Item Name: Crosstube Turning Detail

DART AEROSPACE LTD		Work Order:	114868
Description: Crosstube Assembly		Part Number:	D407-667-145
Inspection Dwg: D407-667-145 Rev: C		Page 1 of 2

DRAWING NO. D407-667-145	TITLE CROSSTUBE ASS'Y (407 HIGH FWD)	REV. C	DART AEROSPACE LTD ENGINEERING ORDER		D.E.O. NO. D407-667-145-C-1	SHEET NO. SHEET 1 OF 1	SCALE NTS
DRAWN <i>q</i>	CHECKED <i>ASS</i>	MFG. APPR. <i>AB</i>	APPROVED <i>WD</i>		DE APPR. <i>HA</i>		
DATE 11.07.15	DATE 11.07.22	DATE 11.07.22	DATE 11/07/22		DATE 11.07.21

DRAWING NO. D407-667-145	TITLE CROSSTUBE ASS'Y (407 HIGH FWD)	REV. C	DART AEROSPACE LTD ENGINEERING ORDER		D.E.O. NO. D407-667-145-C-2	SHEET NO. SHEET 1 OF 1	SCALE NTS
DRAWN AJS		CHECKED [Signature]	MFG. APPR. [Signature]	APPROVED [Signature]	DE APPR. [Signature]		
DATE 12.08.02		DATE 12.08.02	DATE 12.08.02	DATE 12.08.02	DATE 12.08.02

DETAIL P
BONDING STRAP INSTALLATION 2 PL

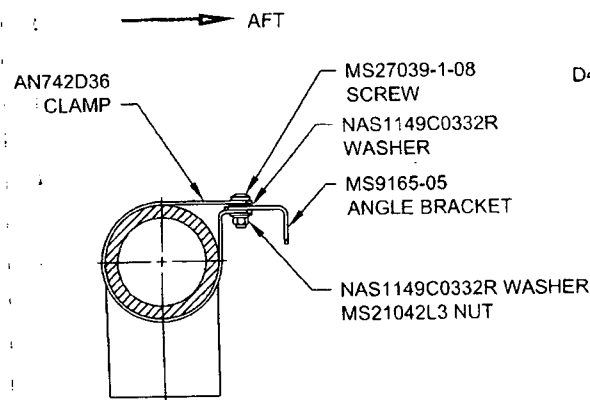
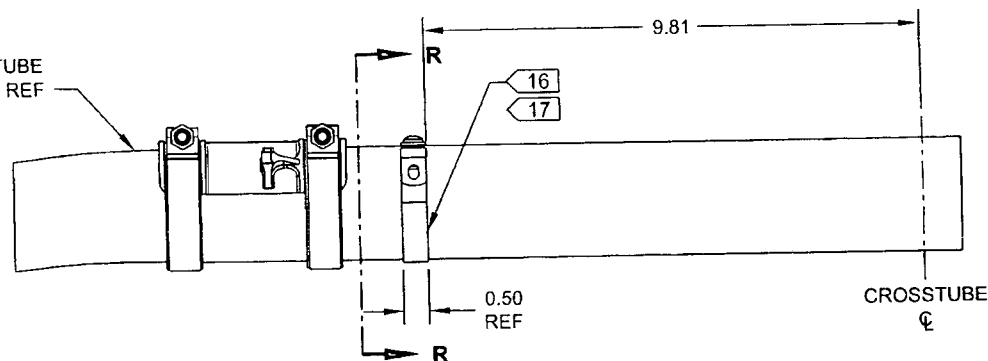
ADD ELECTRICAL GROUNDING STRAP

ITEM	QTY	PART NUMBER	DESCRIPTION
1	X	D407-667-145	CROSSTUBE ASSEMBLY (407 HIGH FWD)
10	2	AN742D36	CLAMP
11	2	MS9165-05	ANGLE BRACKET
12	2	MS21042L3	NUT (OR MS21042-3)
13	2	MS27039-1-08	SCREW
14	4	NAS1149C0332R	WASHER (OR AN960C10L)

- 16) MASK AREA UNDER CLAMP PRIOR TO PAINTING
- 17) SEAL EDGES WHERE AN742D36 CLAMP MEETS WITH THE CROSSTUBE USING SIKAFLEX-241/-291 OR MIL-S-8802 CLASS B2 OR PROSEAL 890 SEALANT
- 18) PERFORM RESISTANCE CHECK TO ENSURE MAX RESISTANCE IS 10 MILLIOHMS
